CITY OF ALBUQUERQUE

**RE: La Mirada
Conceptual Grading and Drainage Plan
Engineer's Stamp Date: No Date
Hydrology File: G19D004A**

Based upon the information provided in your submittal received 03/01/2021, the Conceptual Grading and Drainage Plan **is not** approved for action by the DRB for Site Plan for Building Permit. The following comments need to be addressed for approval of the above referenced project:

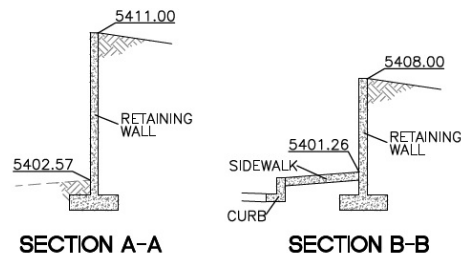
1. Please add the statement "Not for Construction" on both sheets.
2. Where are you relocation the existing storm inlet at the location of the proposed drive entrance? See Below. I recommend relocating the inlet to the east at the end of the proposed drive's curb return.

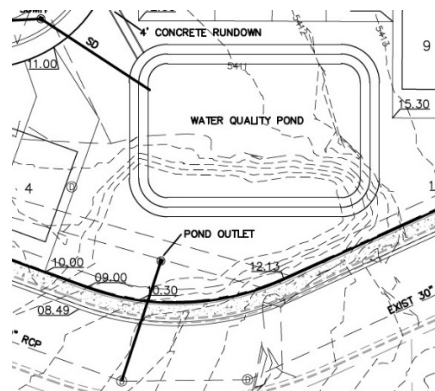
3. Section A-A & B-B. Please provide the property/ROW lines in each section. In accordance with DPM Ch.2-6(H), grading and wall construction near the property line may not endanger adjacent property or constrain its use. Please revise the footer's

location. Construction of the retaining wall footer is not allowed in the R.O.W. without a Revocable Permit.

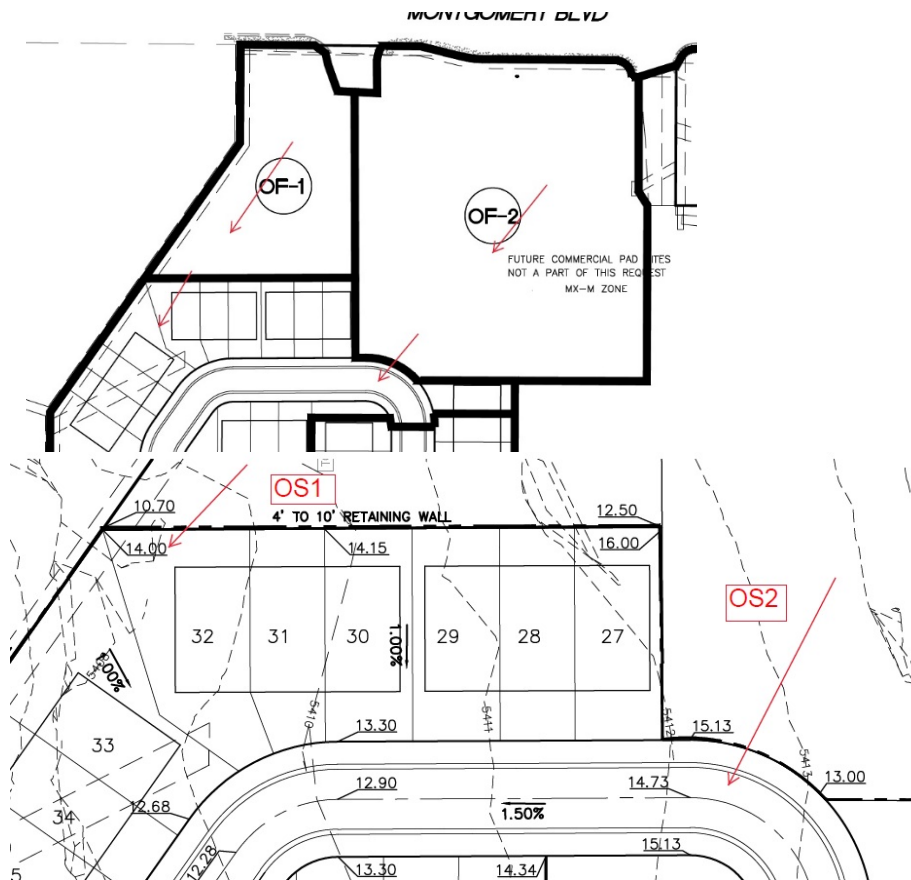
4. This project has new curb & gutter, sidewalk, the inlet from Comment #2, along with the pond outfall pipe, and water & sanitary sewer lines, all of these will be placed on an Infrastructure List. Therefore, the SO-19 notes can be removed.
5. Is the proposed Water Quality Pond going to incorporate the existing pond? The pond outlet is showed in the existing pond location, so that is what I am assuming. If so, please show the proposed contours tying into the existing ones.

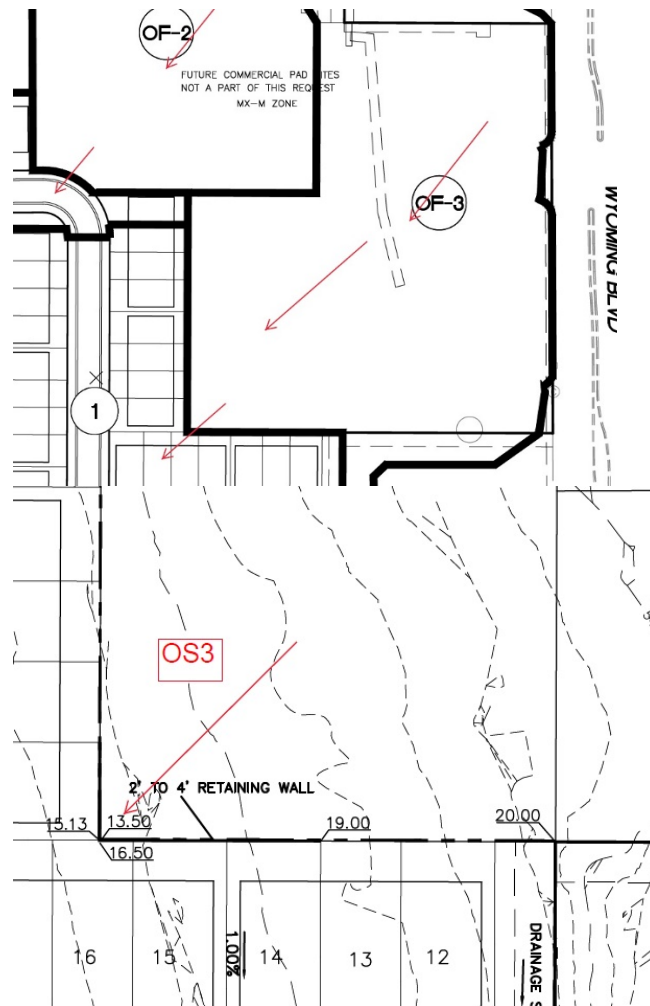
residential area. This is impossible since OS1 & OS2 drains to the southwest and they are located to the north and northeast of the site. If OS1 & OS2 are going to remain commercial, the drainage patterns that exist for shopping center will remain. Therefore, for OS1, how is the runoff going to go through the proposed residential area? Please show the turn block on the retaining wall and please provide a section and calculations for the drainage feature that you are going to use. For OS2, the runoff appears to go over the proposed curb and down the proposed street. Please provide the calculations for street section down stream of the OS2 drainage to ensure that this will be able to make it to the proposed inlets to the south or new inlets may have to be placed where the 100-year drainage cannot be contained within the roadway.

9. Under the proposed drainage, you stated the OS3 will drain to a proposed drainage channel located to the west side of the residential area. This is impossible since OS3 drains to the southwest and is located to the northeast of the site. There is a swale running down the east side of the residential area but OS3 is going to remain commercial and the drainage patterns that exist for shopping center will remain. Therefore, the drainage is going to go at the corner of the retaining walls and pond there. How are you

going to accommodate for this drainage pattern? Please provide a section and calculations for the drainage feature that you are going to use.
